Work Order ID: 110962
 Parent Item: D350-689-011
 Parent Item Name: Dual High Back Seat Installation

DART SERVICE INSTRUCTION

TO AMEND INSTALLATION INSTRUCTIONS IIN-D350-689 REV. B AND INSTRUCTIONS FOR CONTINUED AIRWORTHINESS ICA-D350-689 REV. 1

REF. TCCA STC: SH02-33
REF. FAA STC: SR01620NY
REF. EASA STC: EASA.IM.R.S.01453
REF. TCA STC: 2005S03-09

FIGURE 1: UPDATES TO CROSS SECTIONS F-F AND M-M

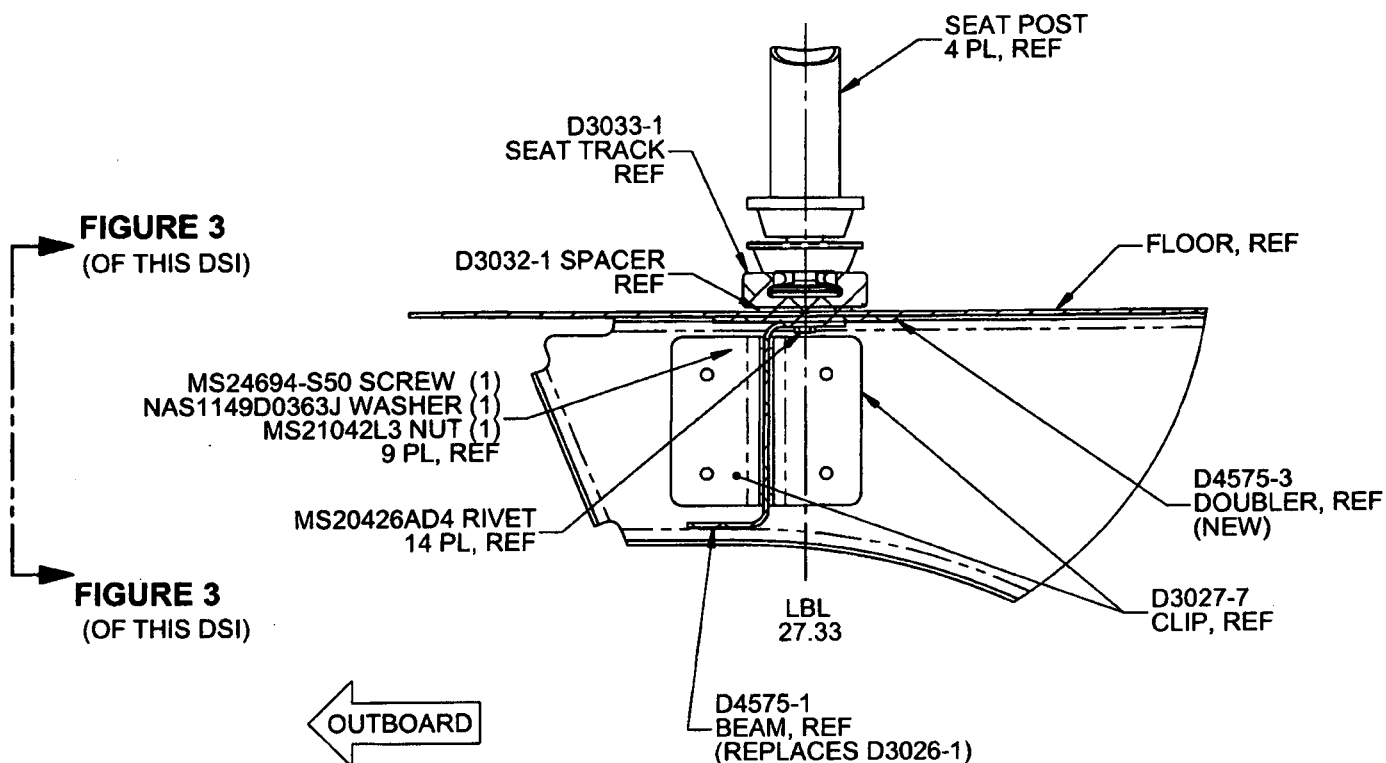
If there is an existing stringer at LBL 27.33, it will need to be removed from that location. Locate D4575-1 Beam, D4575-3 Doubler, and D3032-1 Spacer as shown in Figure 1 of this Service Instruction. Transfer drill existing holes from the aircraft floor to the D4575-1 Beam, D4575-3 Doubler, and D3032-1 Spacer. Ensure 1.0" to 1.5" rivet pitch and add additional holes if required. If there is no existing stringer, locate D4575-1 Beam, D4575-3 Doubler, and D3032-1 Spacer as shown in Figure 1 of this Service Instruction and drill Ø0.128" holes on a 1.0" to 1.5" pitch.

Counter sink holes in the D3032-1 Spacer for MS20426AD4 rivets. Install D4575-1 Beam, D4575-3 Doubler, and D3032-1 Spacer to floor using MS20426AD4 rivets.

CROSS SECTION VIEW F-F/M-M: From Figures 5 and 7 (IIN-D350-689)
CROSS SECTION VIEW F-F/M-M: From Figures 25-5 and 25-7 (ICA-D350-689)

FIGURE 2: UPDATES TO FIGURE 21 (IIN-D350-689) AND 25-21 (ICA-D350-689)

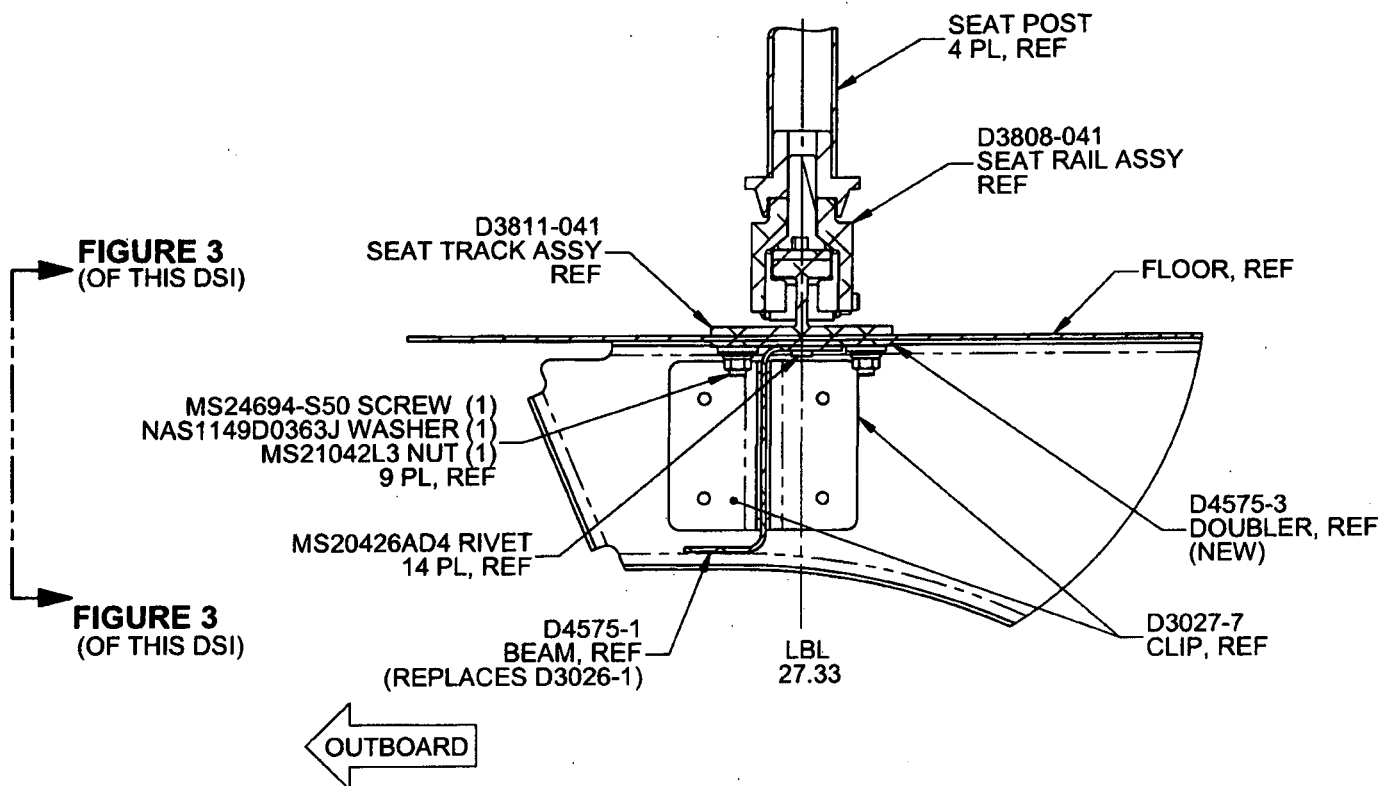
If there is an existing stringer at LBL 27.33, it will need to be removed from that location. Locate D4575-1 Beam and D4575-3 Doubler as shown in Figure 2 of this Service Instruction. Transfer drill existing holes from the aircraft floor to the D4575-1 Beam and D4575-3 Doubler. Ensure 1.0" to 1.5" rivet pitch and add additional holes if required. If there is no existing stringer, locate D4575-1 Beam and D4575-3 Doubler as shown in Figure 1 of this Service Instruction and drill Ø0.128" holes on a 1.0" to 1.5" pitch.

Attach D4575-1 Beam and D4575-3 Doubler to floor using qty (14) MS20426AD4 rivets.

FIGURE 21: Cross Section View T-T from Figure 19 (IIN-D350-689)
FIGURE 25-21: Cross Section View T-T from Figure 25-19 (ICA-D350-689)

FIGURE 3: RELIEFS ON D4575-1/-3
(ONLY D4575-1/-3 SHOWN FOR CLARITY)
VIEW LOOKING INBOARD

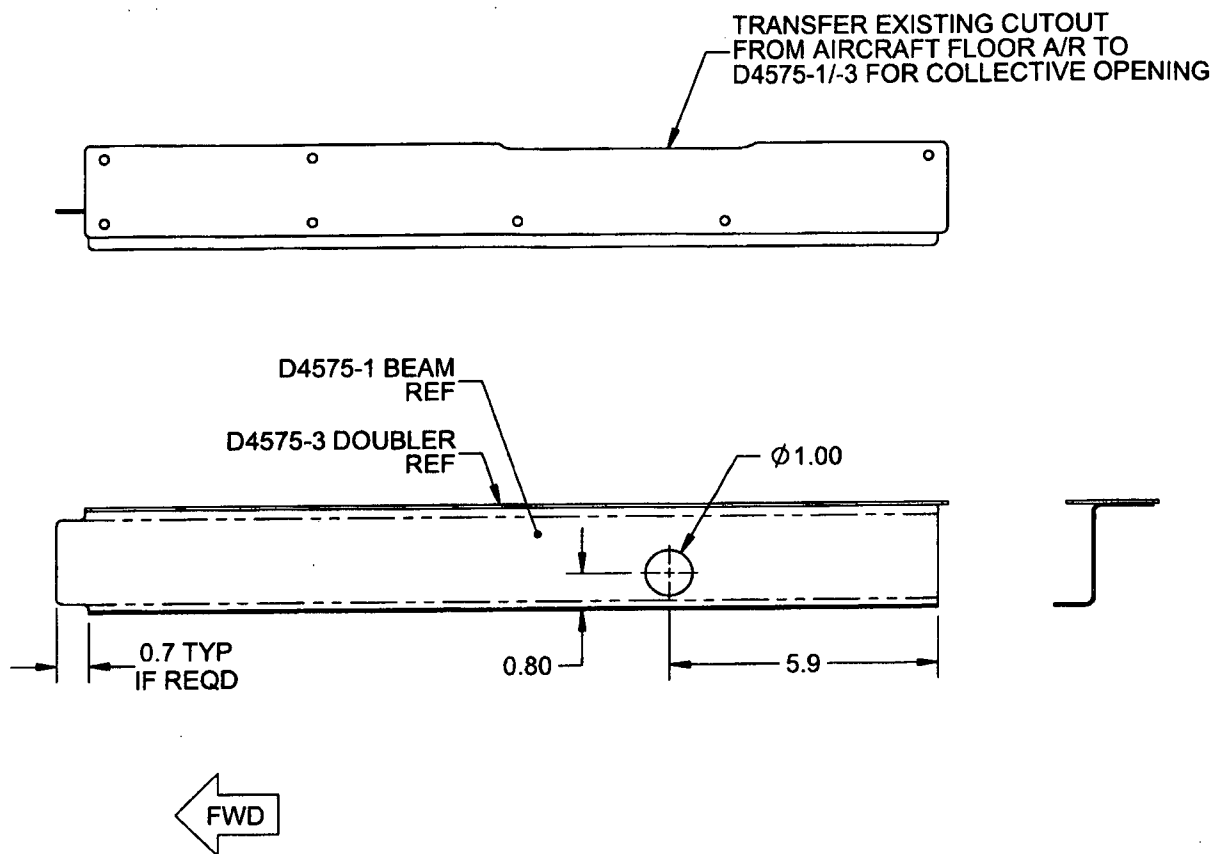
Note: Drill a Ø1.00" (Ø25.4 mm) hole in the D4575-1 Beam to clear extension tube of collective and cutout as required for clearance of collective opening and fwd bulkhead as shown in Figure 3 of this Service Instruction.

Note: Drill a Ø1.00" (Ø25.4 mm) hole in the D4575-1 Beam to clear extension tube of collective and cutout as required for clearance of collective opening and fwd bulkhead as shown in Figure 3 of this Service Instruction.
